# Ground Floor Plan

S4.55 COMPARISON

# Elevation 03 - North Elevation

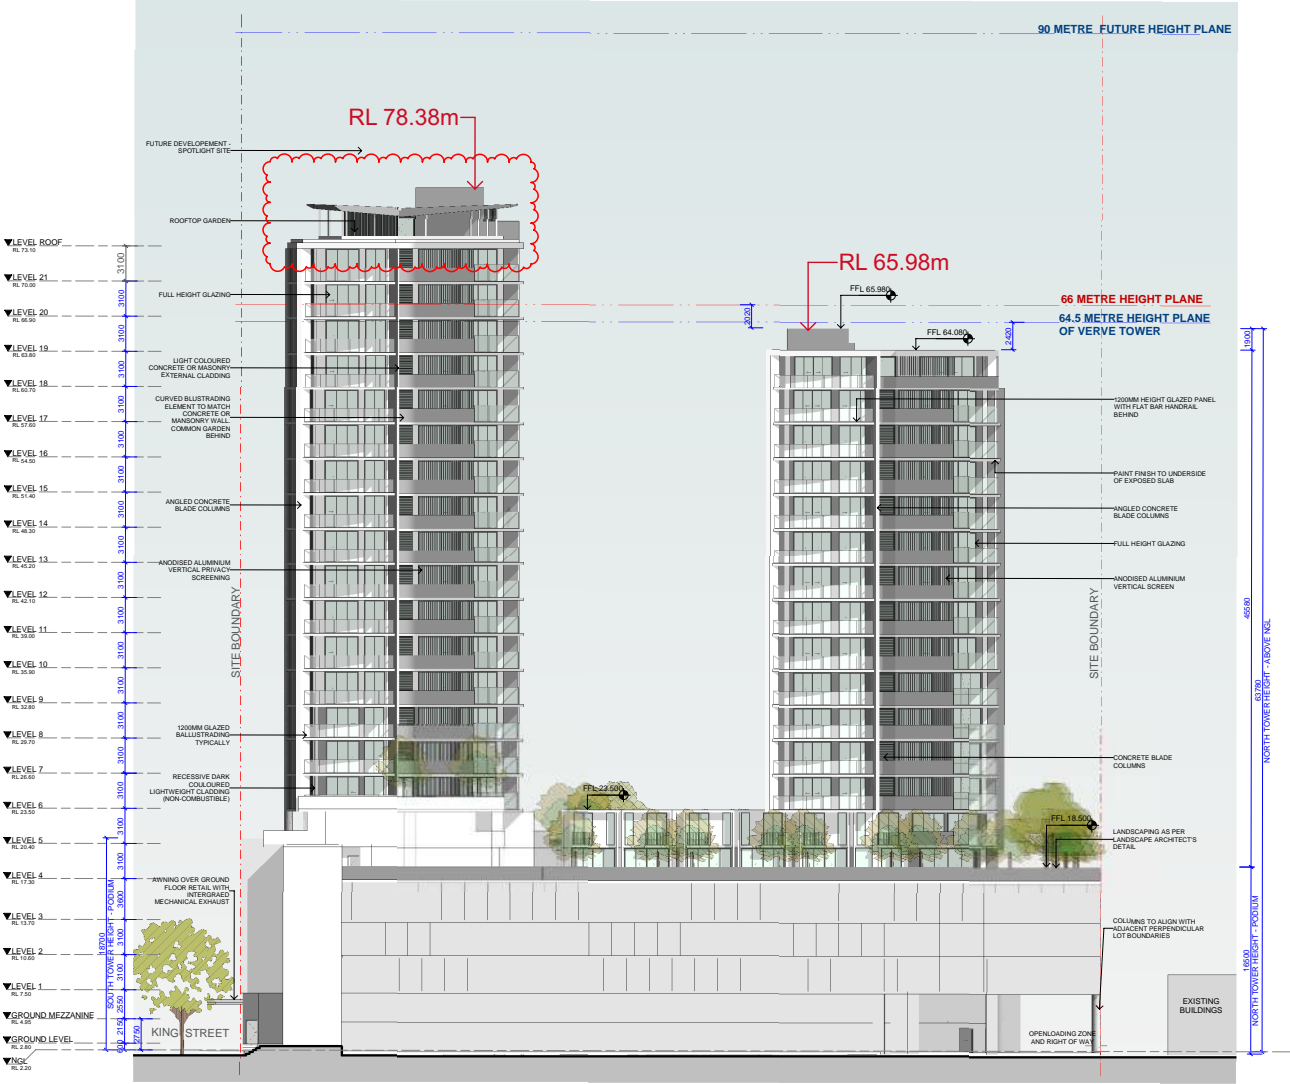
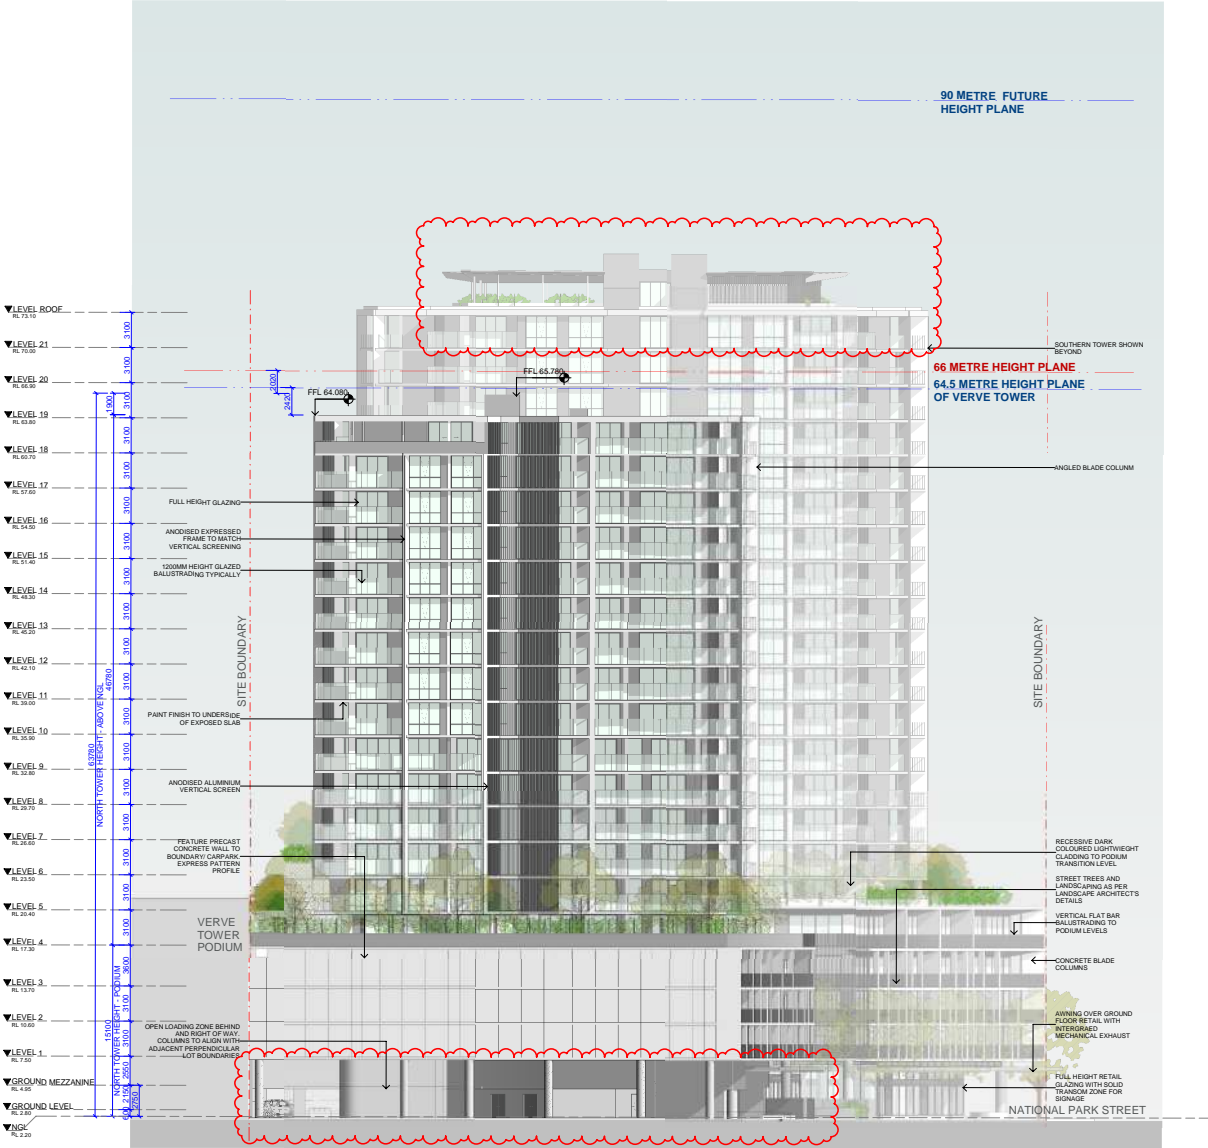
1. The height of the northern tower has increased from 65.98m (top of lift overrun) in the approved DA to 69.75m in the amended DA. An increase of 3.77m.
2. The height of the southern tower has increased marginally from 78.38m (top of lift overrun) in the approved DA to 80.02m in the amended DA. The actual roof level of the South tower has increased by just 630mm from FFL 76.87 TO 77.50.
3. The entire top floor of the Northern tower has now been dedicated entirely to communal functions.
4. Rooftop communal area on South building has increased.

5. Reduce glazing / integrate the proposed pre-cast panels in the tower facades. The architectural language uses vertical blades and columns to create varied interest juxtaposing the horizontal language of the balustrades and slab edges. Vertical screens added to the East and West elevations to enhance the vertical architectural language in lieu of landscape planting to end of corridors.
6. Podium - More clearly defined and articulated row of Dulpexes.

# Elevation 04 - East Elevation

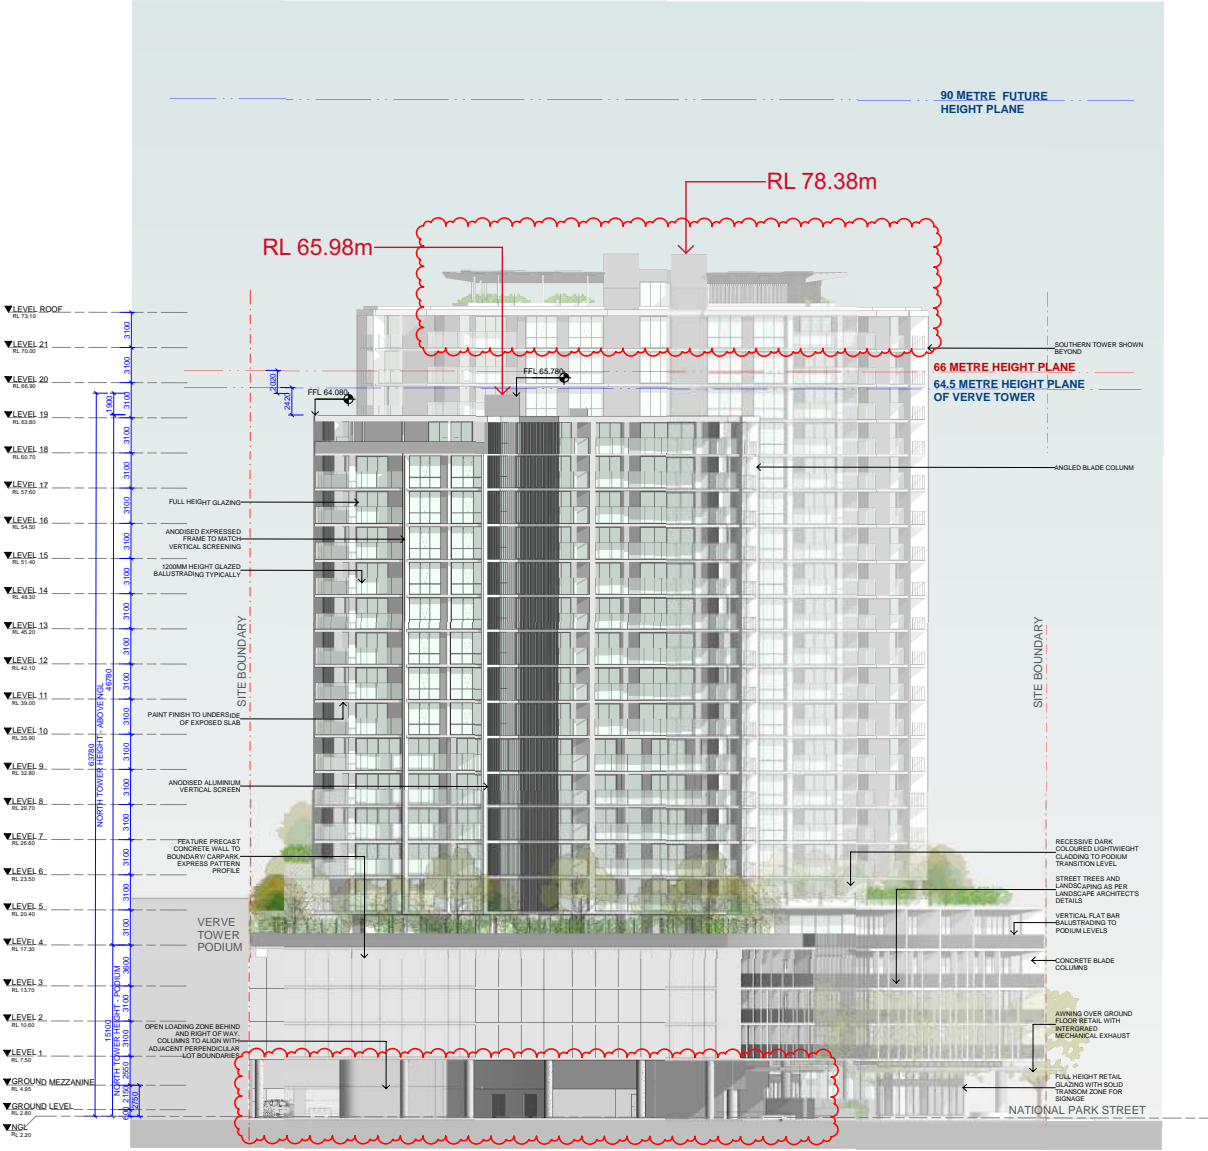
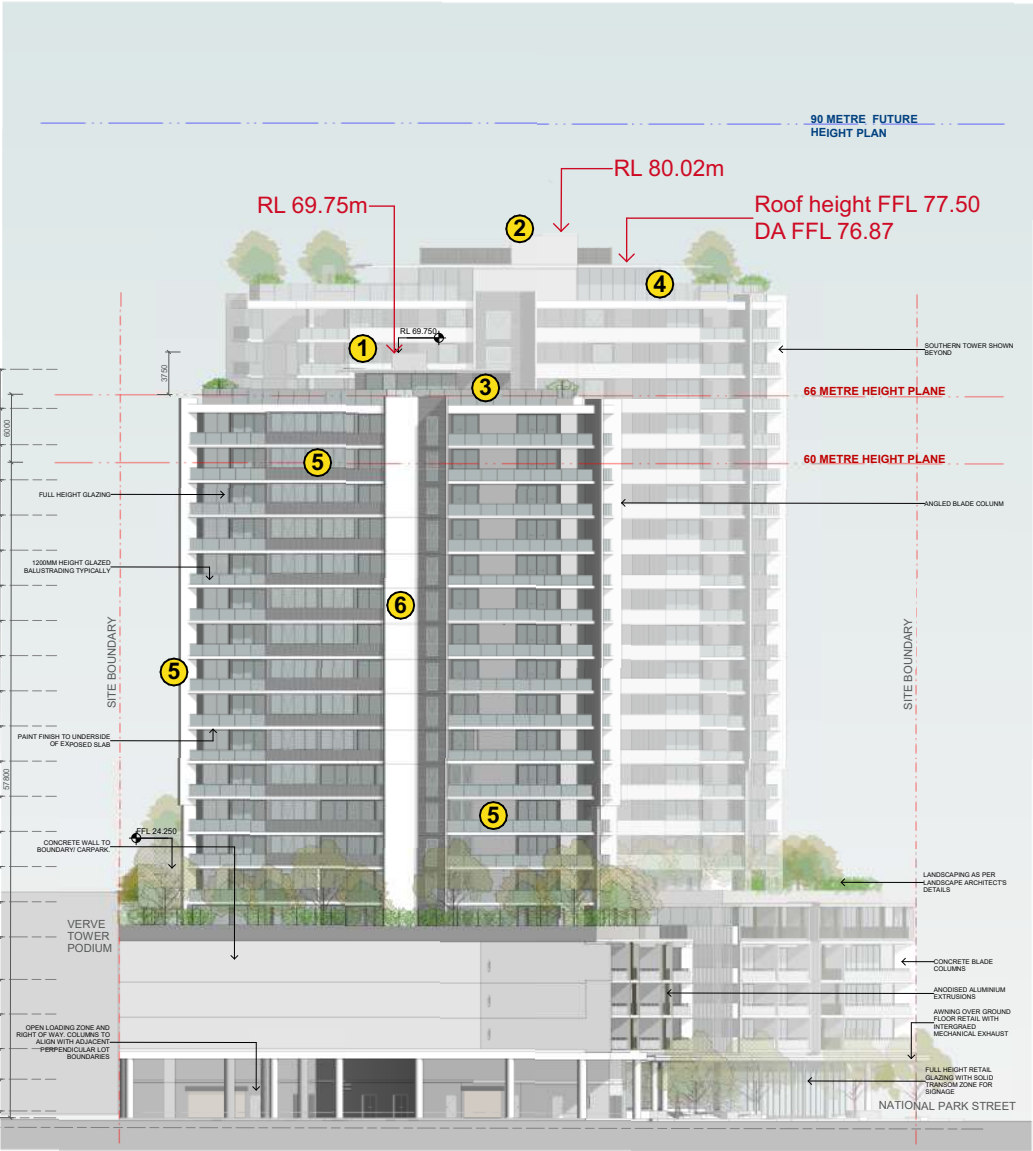
- 1. The height of the northern tower has increased from 65.98m (top of lift overrun) in the approved DA to 69.75m in the amended DA. An increase of 3.77m.
- 2. The height of the southern tower has increased marginally from 78.38m (top of lift overrun) in the approved DA to 80.02m in the amended DA. The actual roof level of the South tower has increased by just 630mm from FFL 76.87 TO 77.50.
- 3. The entire top floor of the Northern tower has now been dedicated entirely to communal functions.
- 4. Rooftop communal area on South building have been increased.

- 5. Reduce glazing / integrate the proposed pre-cast panels in the tower facades. The architectural language uses vertical blades and columns to create varied interest juxtaposing the horizontal language of the balustrades and slab edges.
- 6. A central pre-cast slot has been introduced to articulate the tower forms and address councils request for reduction of horizontal design language on the tower.

# Cross Section

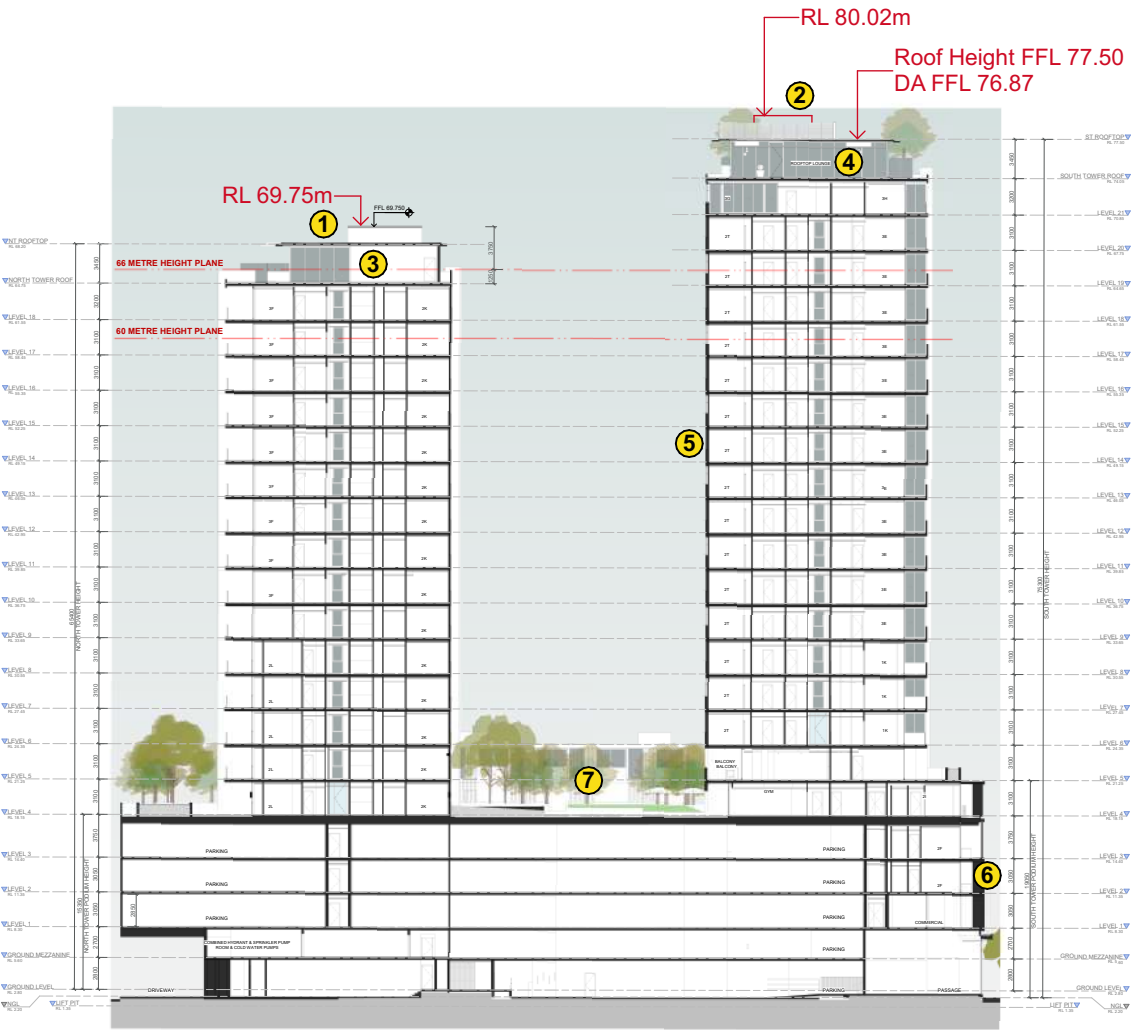
1. The height of the northern tower has increased from 65.98m (top of lift overrun) in the approved DA to 69.75m in the amended DA. An increase of 3.77m.
2. The height of the southern tower has increased marginally from 78.38m (top of lift overrun) in the approved DA to 80.02m in the amended DA. The actual roof level of the South tower has increased by just 630mm from FFL 76.87 TO 77.50.
3. The entire top floor of the Northern tower has now been dedicated entirely to communal functions.
4. Rooftop communal area on South building have been increased.

5. Reduce glazing / integrate the proposed pre-cast panels in the tower facades. The architectural language uses vertical blades and columns to create varied interest juxtaposing the horizontal language of the balustrades and slab edges.
6. Solid balustrades to podium levels have been introduces along with enclosed sections of glazing to improve resident amenity and address noise and privacy issues, particularly along King Street.
7. Enhance communal spaces with better amenity, including pool and podium.
